Technical Service Bulletin: TSB250125

New Engine Wiring Harnesses

#### Product Affected

- QST30 CM552
- QST30 CM850

Figure 1, Engine Left Bank Fuel Lift Pump Relay Location.

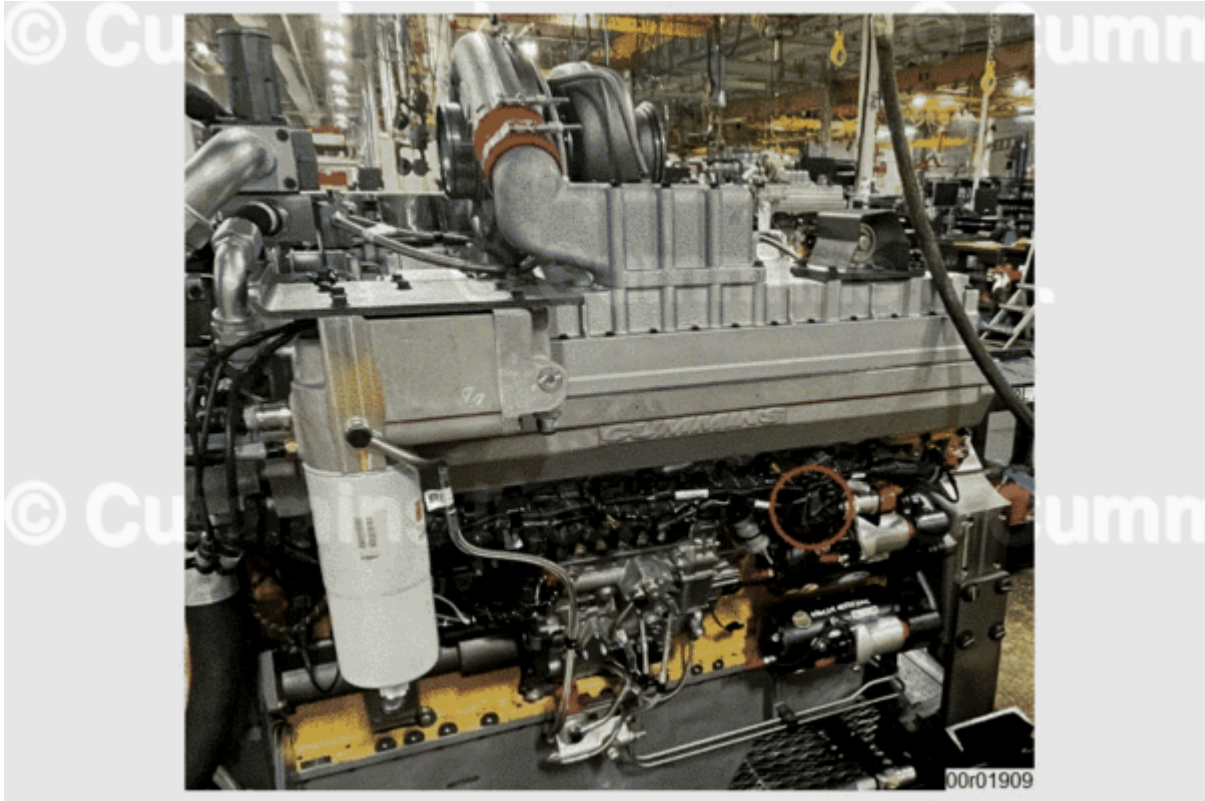
- New engine wiring harnesses are released in correspondence with the new 3-pump electric fuel lift pump system.
- There are now three electric fuel lift pump power connections on the engine wiring harnesses. The branch of the engine wiring harness that includes the fuel lift pump relay has also been extended in length to achieve a more accessible location when installed on-engine and increased in wire gauge to the appropriate size for the new system. Depending on the mounting location of the fuel lift pump and filter head assembly, the fuel lift pump harness assembly may be routed in one of two paths, as shown in Figures 1 and 2. The wiring diagrams have been updated for all possible engine wiring harness options.
